## TRIOMATIC COUPLINGS WITH IMPROVED DESIGN

With a new TrioMatic design we have responded to the stringent requirement of customers to differentiate the WABCO TrioMatic coupling from copy or fake parts.

*New WABCO TrioMatic couplings*

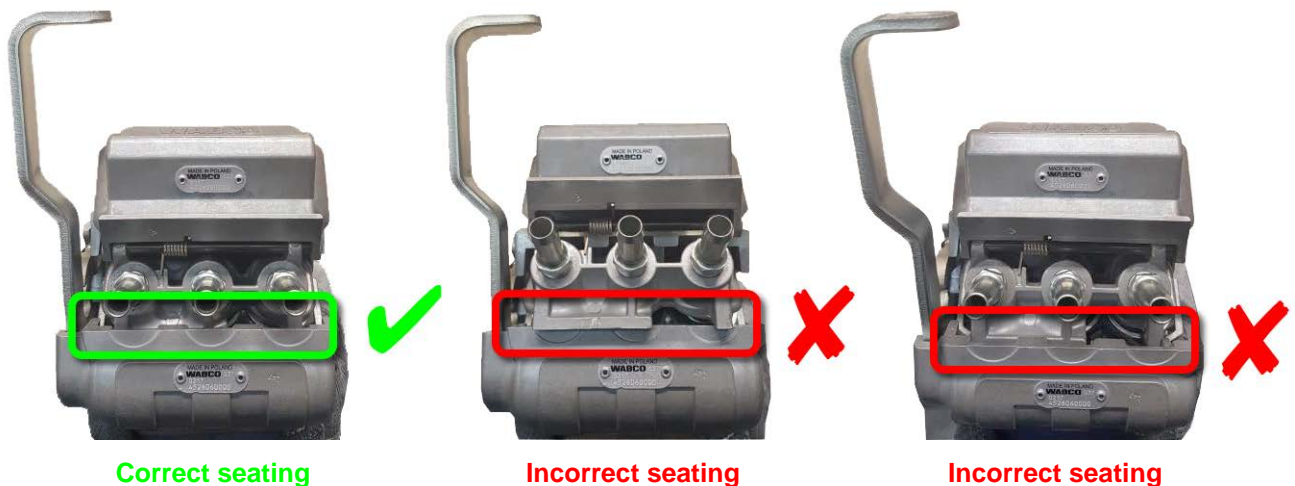
We have improved the design of this safety component by making adjustments to the wear-intensive areas, casting and overall product appearance.

- Male part coupling forehead is machined to provide better sealing
- Using a different casting method made the parts lighter while maintaining corrosion resistance and strict tolerances
- The look of the part has been improved by implementing the WABCO corporate design
